**Public Hearing for Southport West Replat 5—
Preliminary PUD, Preliminary Plat, & Final Plat**

RECOMMENDATION REPORT

CASE NUMBER: 2014-PUD-04; 2014-SUB-06 FOR HEARING OF: July 17, 2014
Report Prepared on: July 10, 2014

RE: Preliminary PUD, Preliminary Plat, Final Plat -Initial Review
Southport West Replat Five
City Engineer Review Comments

AUTOTRACK DETAIL
NOT TO SCALE

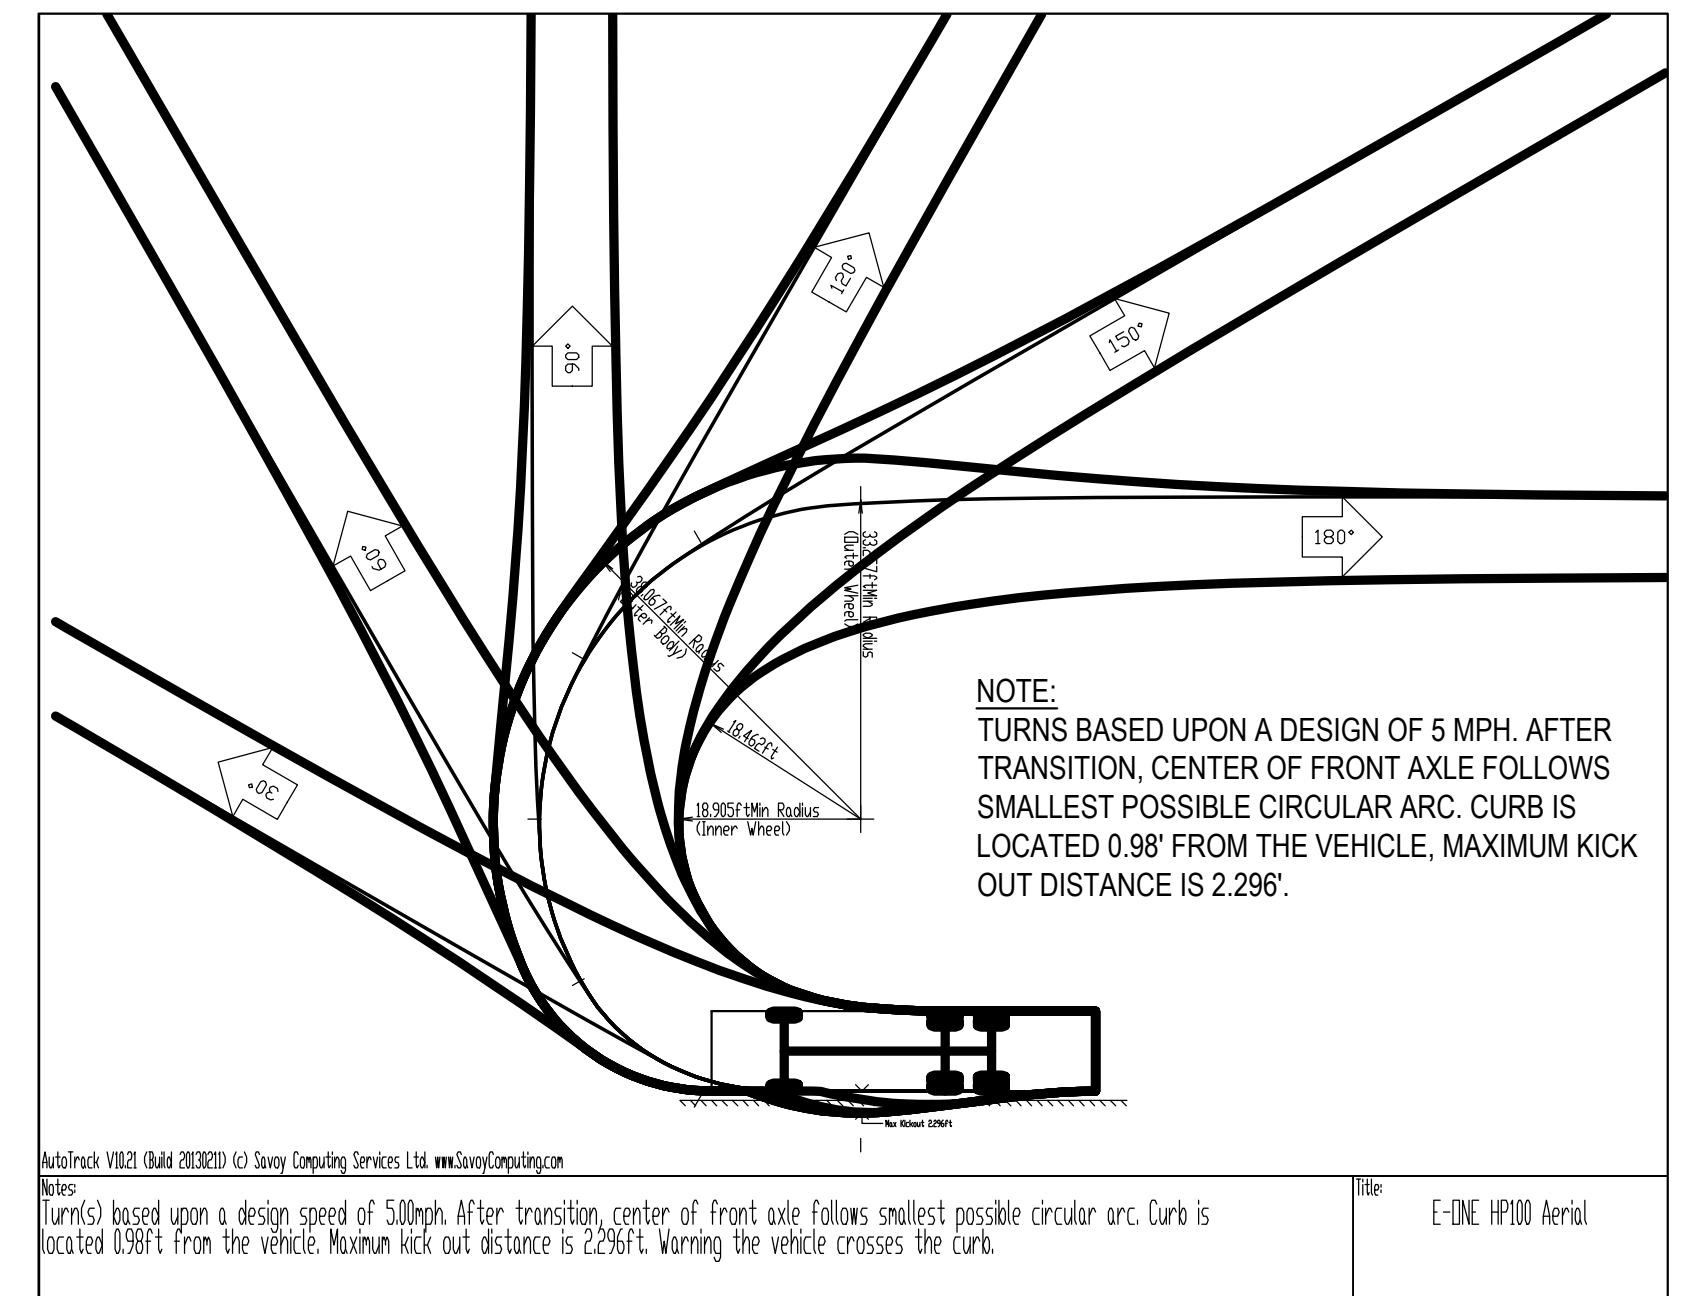
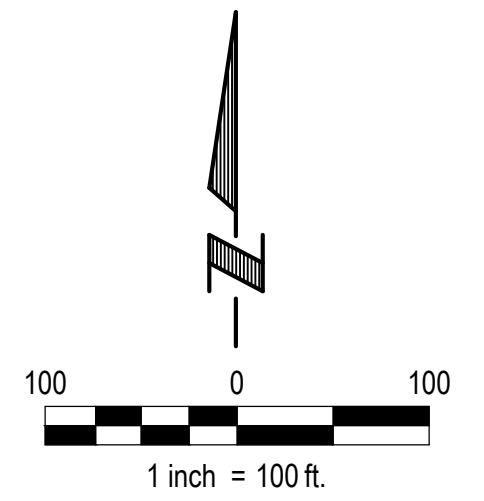
7. The Site Parking Table on the Emergency Vehicle Exhibit shows Lot 4 to be a retail use. However, I understand this building is to be used for an Assembly type use. The potential occupancy as an assembly type use needs to be indicated so that adequacy of parking for that use can be reviewed. The Site Parking Table contains a note indicating shared parking between Lots 3 and 4 but not with the remaining lots. Under that scenario, the remaining lots appear to have an abundance of parking for the uses indicated. An example is Lot 5 at a ratio of 8.65 stalls per 1,000 and Lot 1 having more stalls than would be necessary for the intended use. Ordinance No. 1013 allowed for parking in aggregate to be 4.5 stalls per 1,000 square feet. If the proposed use of Lot 4 necessitates the overall parking count, then that should be clarified and allowed with appropriate cross parking easements.

13. The Emergency Vehicle Exhibit needs to be reviewed by the Fire Marshall. The class of vehicle and/or dimensions of the vehicle used for the turning paths needs to be labeled on the plan. There may be some curb radii that need to be adjusted.

2. Fire access lanes appear to be listed as 20' in width. They are required to be a minimum of 24' wide.
3. Though the plans include apparatus turning radii, I would like to see a plan illustrating those radii as approached from all directions. It appears that though possible to negotiate some of the turns from a particular direction, it may not be possible to negotiate the same turn from the opposite direction, which is necessary.

4. Again, regarding the turning radii; many of the turns bring the apparatus extremely close to the medians. When the lanes are expanded to 24' this may eliminate the issue.

5. It appears that some of the landscaping may present problems again with the turning radii. The plans do not indicate the expected dimensions of the trees planted in the medians at the turning points. I am concerned that as the trees grow they will impede the ability of an apparatus to negotiate the necessary turns to access all of the property.
